Hi-Fi Products
Service Bulletin

Model: CDP-C235
CDP-C335

No. 390

Subject: Motor Drive Circuit Modification

Subject: Part Number Missing - Reference No. -, Main Chassis

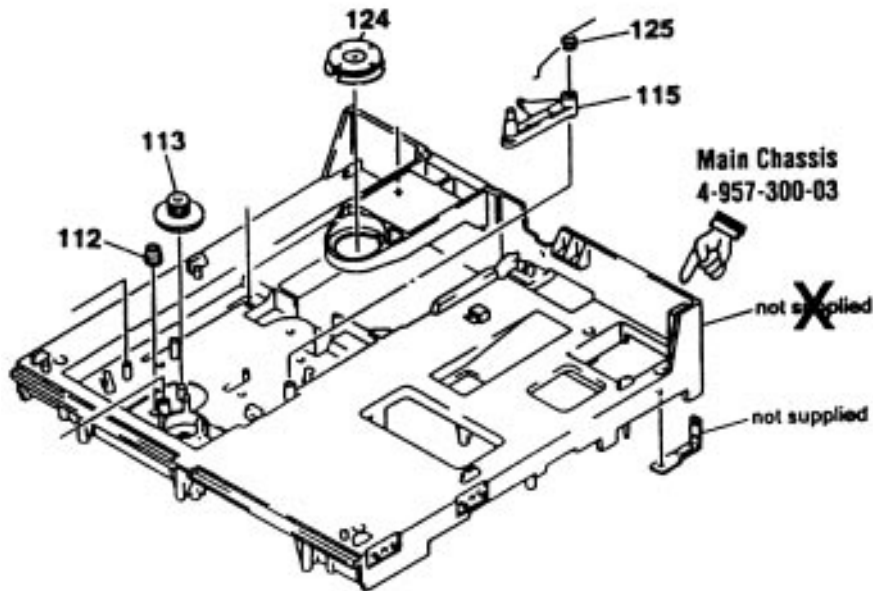
The part number for Ref # -, Main Chassis, which is shown on page 23 of the Service Manual, is not listed in the parts list.

Please add the following part number to the Service Manual.

REF	DESCRIPTION	PART NUMBER
-	MAIN CHASSIS	4-957-300-03

CORRECTION

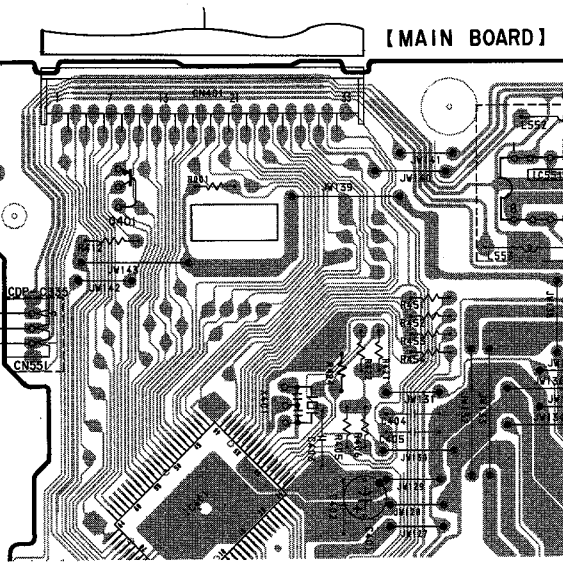
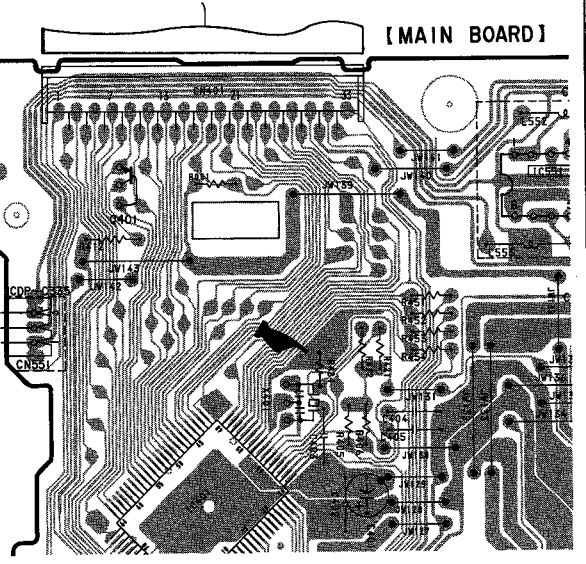
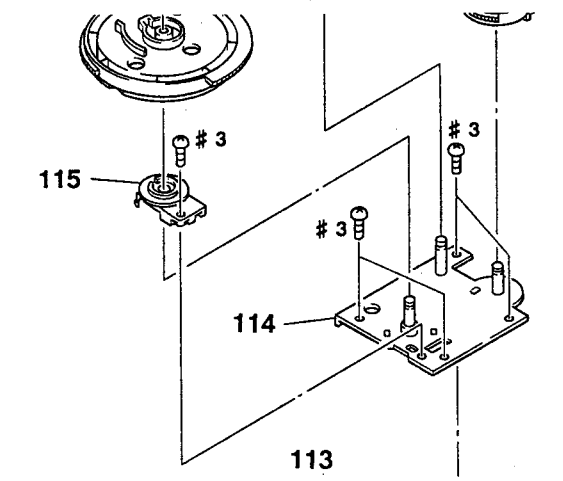
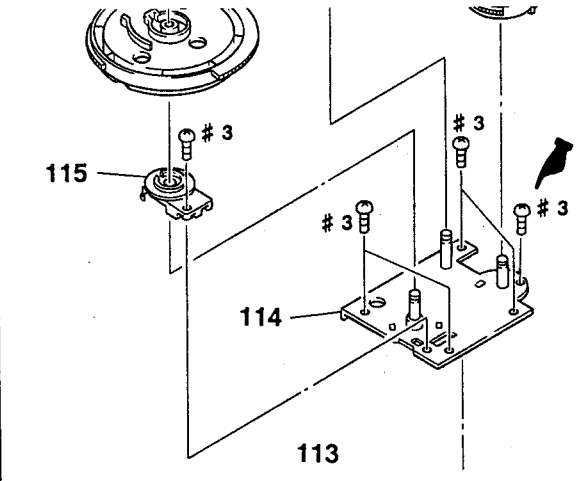
Page	Incorrect	Correct
13	 <p>[MAIN BOARD]</p>	 <p>[MAIN BOARD]</p>
23	 <p>115 #3 #3 #3 #3 114 113</p>	 <p>115 #3 #3 #3 #3 114 113</p>
	121 4-958-593-01 SPRING (BU), COMPRESSION	121 <u>4-948-503-01</u> SPRING (BU), COMPRESSION

Subject : Positioning the Encoder When Attaching the Gear (MAIN)

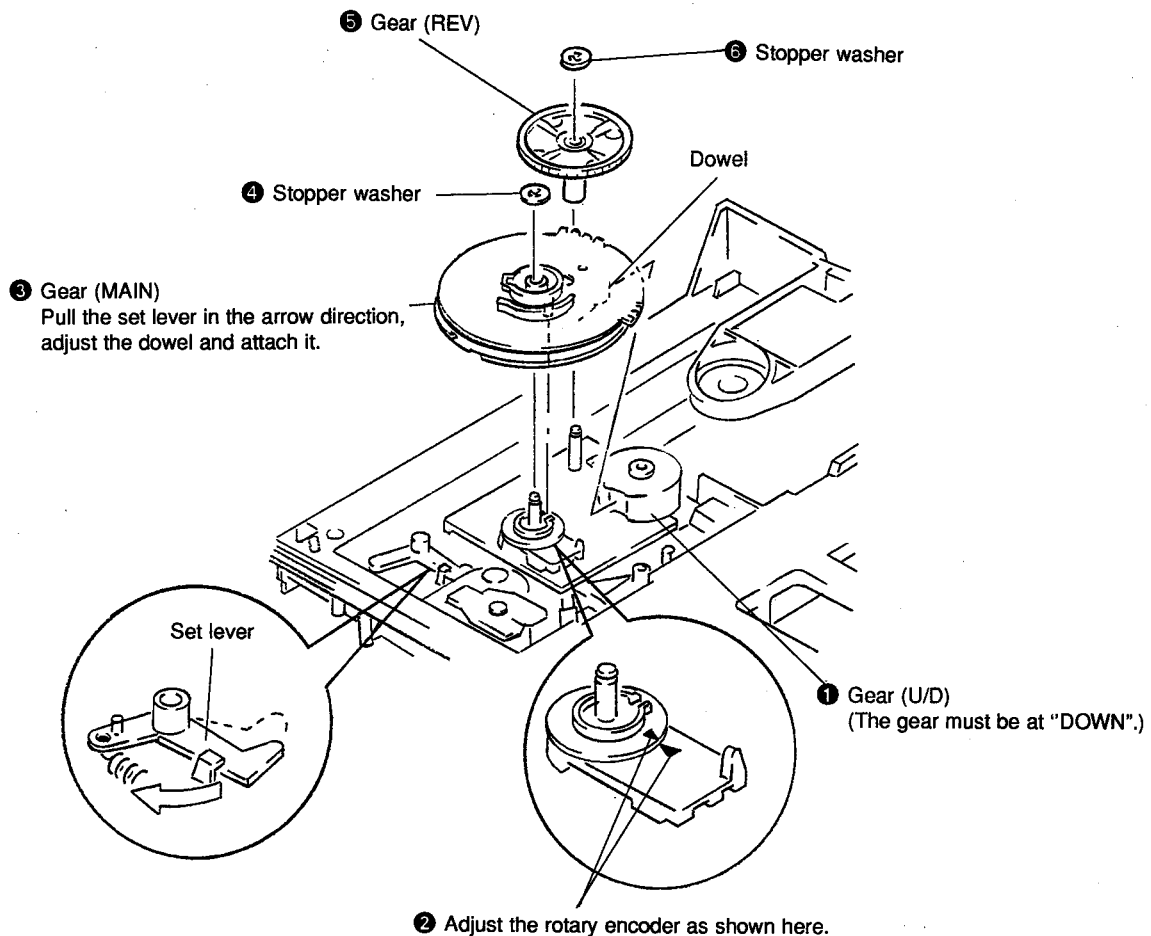
The position of the rotary encoder must be adjusted when attaching the gear (MAIN). If its position is not adjusted properly, problem may occur afterwards during operation.

Please correct your Service Manual.
6-3. CHASSIS ASSEMBLY (Page 23)

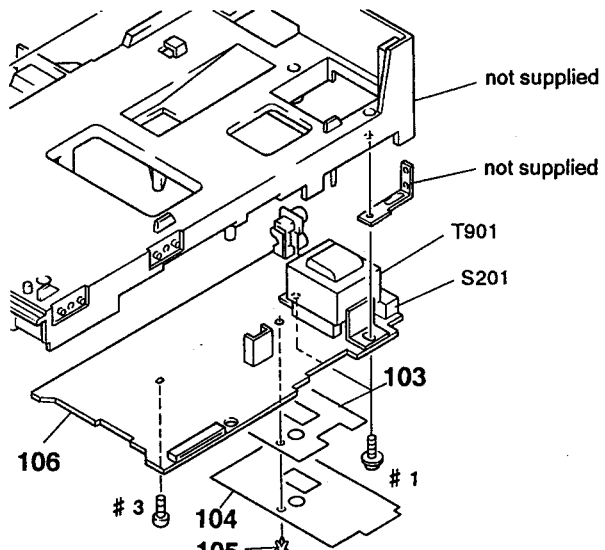
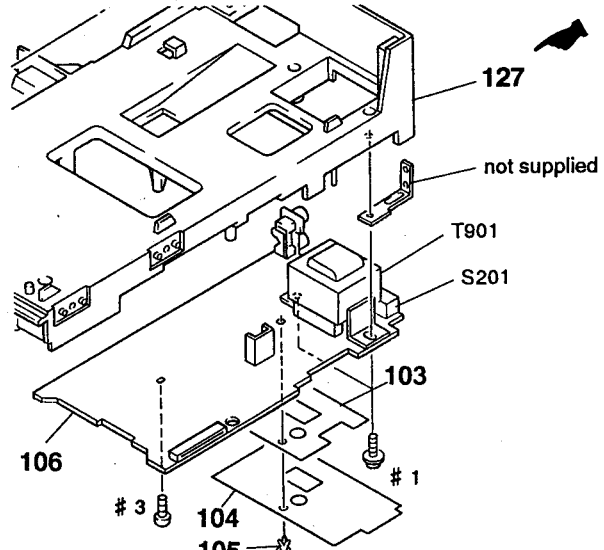
Incorrect				Correct

<u>Ref. No.</u>	<u>Part No.</u>	<u>Description</u>	<u>Remark</u>	<u>Ref. No.</u>	<u>Part No.</u>	<u>Description</u>	<u>Remark</u>
				* 127	4-957-300-03	CHASSIS

Subject: Substitution for KSS-390A

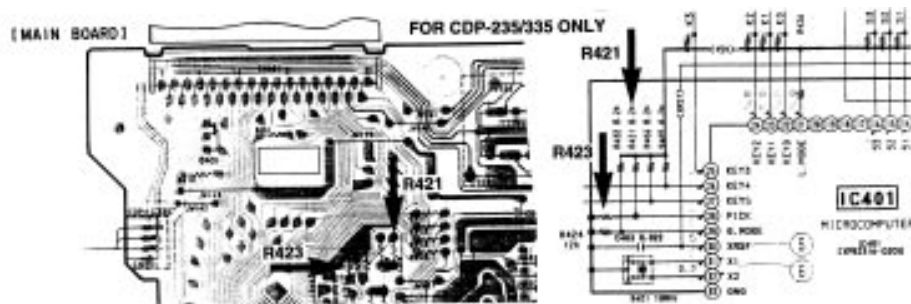
The Optical Block KSS-390A is no longer available and KSS-240A is supplied as the substitution. As the two parts have some electrical and mechanical differences, please perform the following changes according to the model being serviced.

1. Check the value of R421. If it is 8.2K Ω or less, leave it in circuit. Otherwise, remove it and replace it with a jumper wire.
2. Confirm the existence of R423. If it is mounted, remove it. This is needed to keep pin 28 of IC401 High when operating CD function.
3. Replace the flat wire which connects the BD Board and Optical Block with the new type listed below.

Just replace the flat cable with the new type. No circuit modifications needed.

Description	Part Number	Note
Flat Cable	1-575-001-11	This cable must be used with KSS-240A
